ST/SG/AC.10/32/Add.2
23 February 2005

**COMMITTEE OF EXPERTS ON THE TRANSPORT OF
DANGEROUS GOODS AND ON THE GLOBALLY
HARMONIZED SYSTEM OF CLASSIFICATION
AND LABELLING OF CHEMICALS**

REPORT OF THE COMMITTEE OF EXPERTS
ON ITS SECOND SESSION

**Amendments to the fourth revised edition of the Recommendations on the Transport
of Dangerous Goods, Manual of Test and Criteria**

Figure 41.1: Minimum SRS Curve

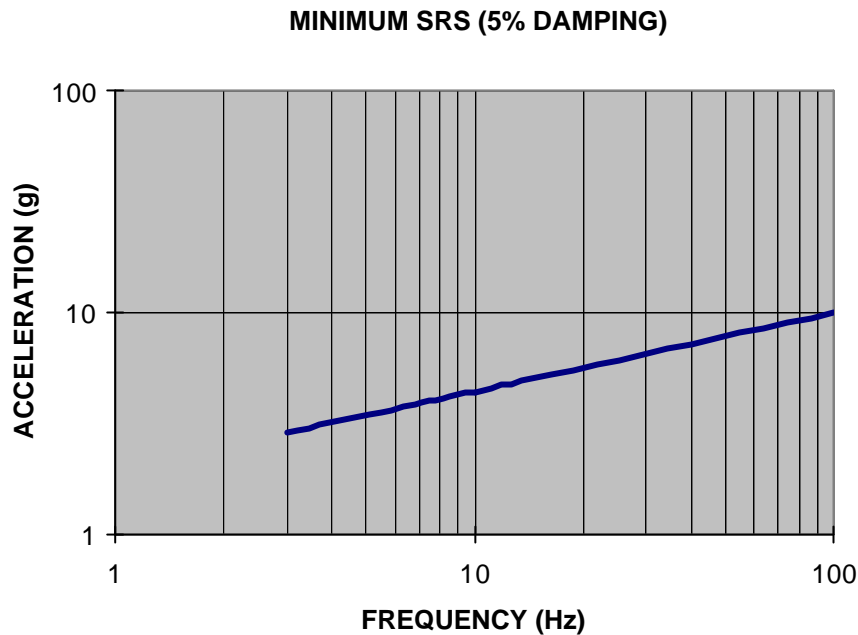
41.3.4.4 An impact shall be created (see 41.3.2) such that for a single impact the as tested Shock Response Spectrum (SRS, see 41.3.5.1) curve at both corner fittings at the impacting end equals or exceeds the minimum SRS curve shown in Figure 1 at all frequencies within the range from 3 Hz to 100 Hz. Repeated impacts may be required to achieve this result but the test results for each impact shall be considered individually;

41.3.7 *Alternate test severity validation method for portable tanks with frame length of 20 feet*

41.3.7.1 If the design of a tank container-under-test is significantly different from other containers successfully subjected to this test and the SRS curves obtained have correct features but remain below the minimum SRS curve, the test severity may be considered acceptable if three successive impacts are performed as follows:

Equation for generating the above Minimum SRS Curve: $ACCEL = 1.95 \text{ } FREQ^{0.355}$

Table 41.1. Tabular representation of some data points for the minimum SRS curve above.

FREQUENCY (Hz)	ACCELERATION (g)
3	2.88
10	4.42
100	10.0

Figure A5.1: 10 LITRE VESSELS FOR VENTING TESTS"

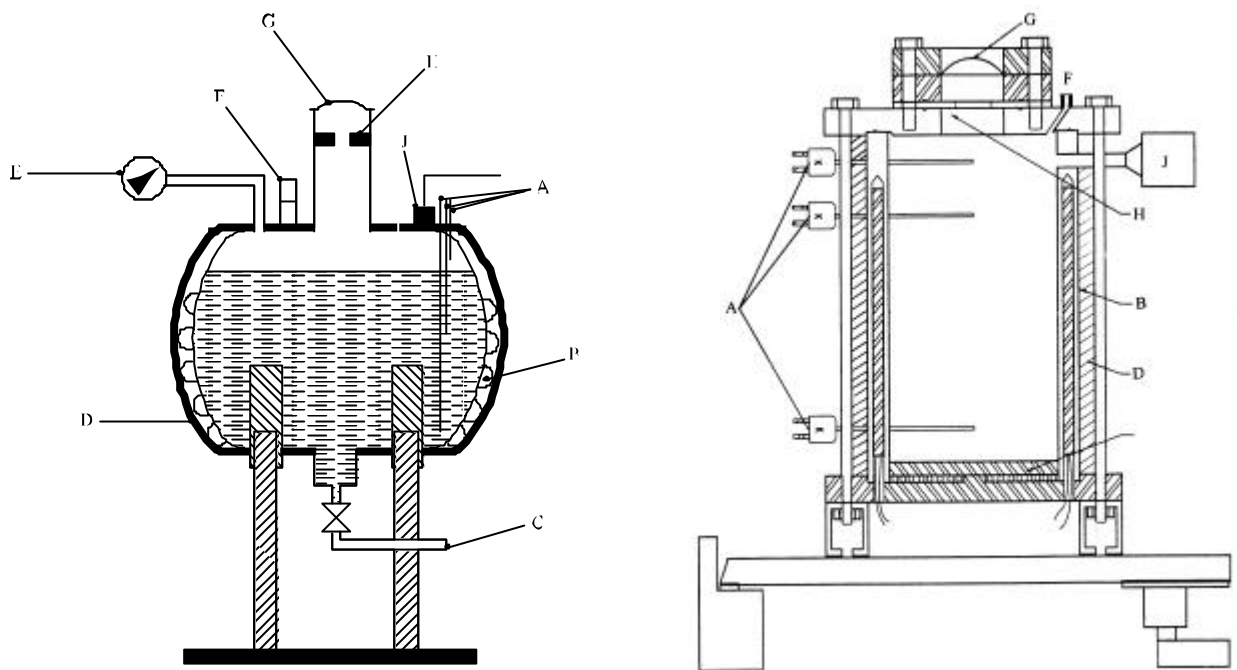
APPENDIX 5

Amend to read as follows:

The reduced scale tank consists of a stainless steel test vessel with a gross volume of 10 l. The top of the tank is provided with either a 1 mm opening which simulates the pressure relief valve (PRV) of the IBC or tank or a real PRV of a diameter which is scaled using the vent area to vessel volume ratio. A second opening simulates the emergency vent opening and is closed by a bursting disk. The diameter of this vent opening can be varied by using orifice plates with different apertures. The bursting pressure of the disk fixed to the 10 l vessel should be equal to the maximum rupture pressure of the bursting disks to be fitted to the IBC or tank. This pressure should be lower than the test pressure of the tank involved. Usually, the bursting pressure is set at a level that can cope with the pressures encountered during normal transport conditions such as hydrostatic pressure from the liquid due to turn over of the tank, slopping of the contents, etc. The 10 l vessel should be provided with a bursting disk with a set pressure in the range of the disk(s) fitted on the tank or IBC as to be used in transport. For safety, it is recommended to provide the test vessel with an extra bursting disk (bursting pressure approximately 80% of the design pressure of the 10 l test vessel) with a large opening for additional emergency venting of the test vessel in the event that the chosen orifice diameter is too small.

The outer surface of the test vessel, below the liquid level, is provided with an electrical heating coil or cartridge heaters connected to a power supply. Vessel contents should be heated at a constant rate independent of the heat being generated by the organic peroxide or self-reactive substance. The resistance of the heating coil should be such that, with the power available, the calculated heating rate (see section 3) can be achieved. The whole vessel is insulated with rock wool, cellular glass or ceramic fibre.

The temperature inside the tank is measured by means of three thermocouples, two located in the liquid phase (near the top and bottom) and one in the gas phase. Two thermocouples are used in the liquid phase to check the homogeneity of the heating. The pressure is recorded by a pressure transducer(s) capable of recording slow and fast (at least 1000 points/sec.) changes of pressure. Examples of test vessels are illustrated in Figure A5.1. Additional information may be obtained if the tank is mounted in a tray designed to collect any solids or liquids ejected.
